NEW MEXICO OIL CONSERVATION DIVISION
 - Engineering Bureau -
 1220 South St. Francis Drive, Santa Fe, NM 87505

ADMINISTRATIVE APPLICATION CHECKLIST

Walter Lynch NSP & SD Application

Walter Lynch Lease
 No. 4, 6 and 8
 Non-Standard Proration Unit
 Blinebry Oil & Gas Pool
 Section 1-T22S-R37E
 Lea County, New Mexico
 Scale: 1" = 1000'

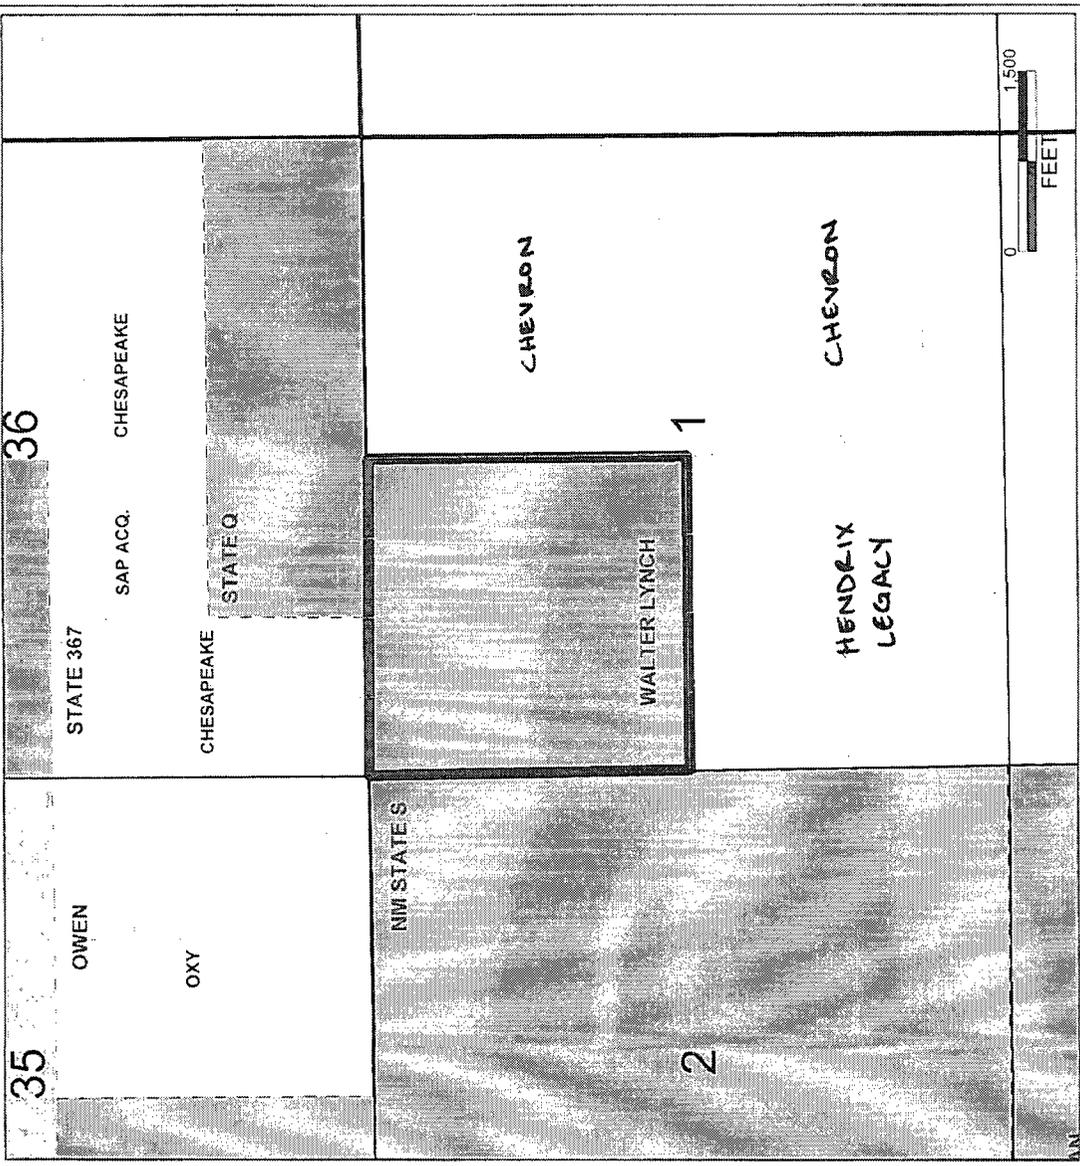
The plat that you sent me on Dec. 8 shows Apache as the operator of the SE/4 SW/4 and S/2 SE/4 of Section 36, adjoining the referenced unit to the north and northwest.

Although the textual portion of the plat does not identify the operator of Section 2 to the west, it would seem Apache also operates that acreage.

For the tracts that Apache operates, if there are other working interest owners, notice is required to any working interest owner who owns a larger interest in the offsetting tract than in the tract that is the subject of the application. Are there any such owners? If so, have they been notified?

Please see revised list of Offset Operators. Apache is one of the operators in Section 2-22S-37E, however, ExxonMobil is the offset owner I should have listed because they are the operator of the Blinbry, Tubb and Drinkard formations. Exxon was notified of Apache's request for administrative approval, via letter dated Nov. 30th, 2009. As to the other tract in which Apache operates (SE/4SW/4 & S/2SE/4 Sec 36-21S-37E), Apache owns 100% working interest.

Walter Lynch Lease
No. 4, 6 and 10
Simultaneous Dedication
Tubb Oil & Gas Pool
Section 1-T22S-R37E
Lea County, New Mexico
Scale: 1" = 1000'

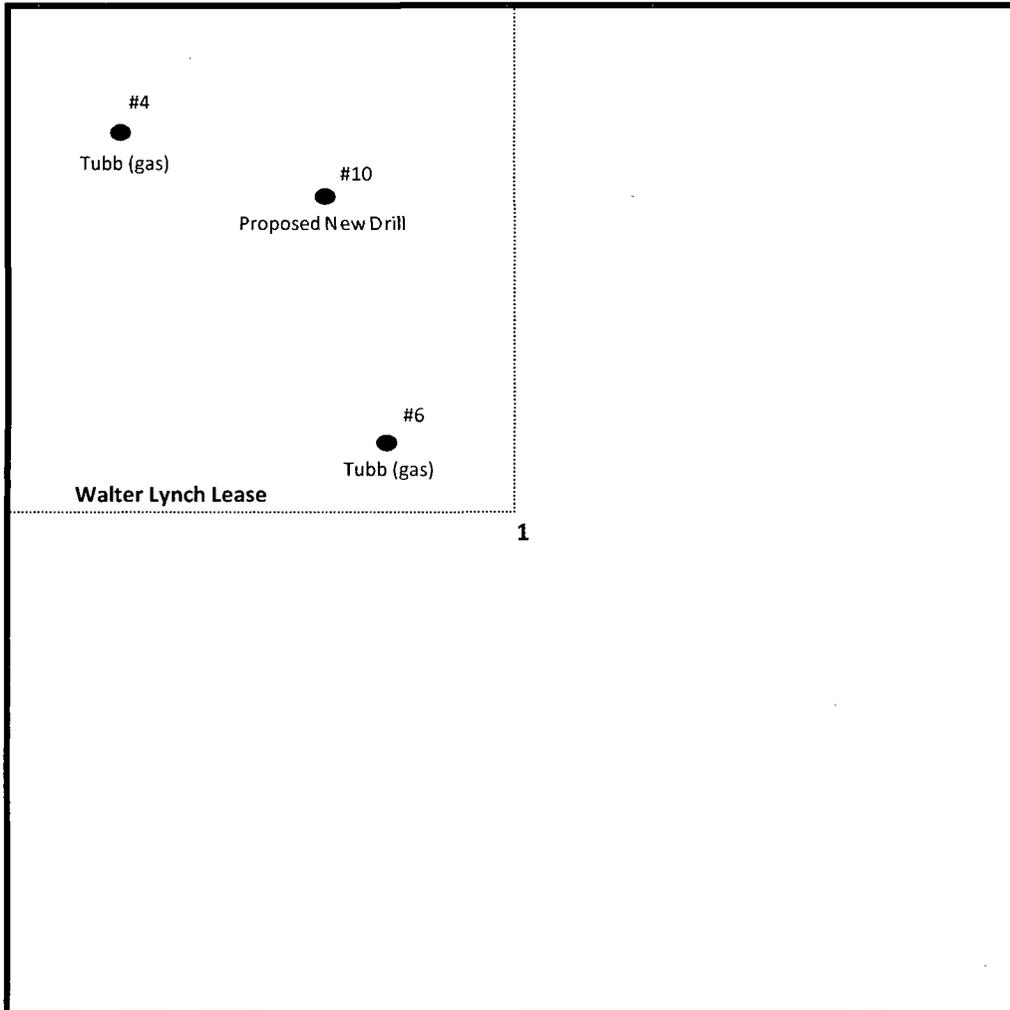
You have requested simultaneous dedication of the Walter Lynch ## 4, 6 and 10 in the Tubb Gas Pool to a 160-acre unit comprising the NW/4 1-22S-37E.

The #4 and #6 are at unorthodox locations for a 160-acre gas unit, because they are each less than 160 feet from unit boundaries.

Are there existing NSL orders approving these locations. If not, you will need to submit NSL applications for these wells.

Please file and NSL application with appropriate notices. In the meantime, I will write an order granting your request for NSPs in the Blinbery, and dismissing your application in the Tubb w/o prejudice. You can renew your SD application when you file the NSL applications. New notices on the renewed SD application will not be necessary.

I cannot find an NSL for either the #4 or #6 wells for the Tubb Gas Pool. However, it looks like the 160-acre gas unit was approved back in 1954 for the #4 well and in 2005 for the #6 well, as to the Tubb Gas Pool. Would I need to submit a true NSL application or can I submit a request letter requesting retro-active approval?

David,
I think we will need to do the NSLs because there are no orders, just an NMOCD approved dedication plat. I'm not sure why the previous operators weren't asked to submit an NSL at the time they submitted a new dedication plat, but I couldn't see any specific NSL approval for either well.
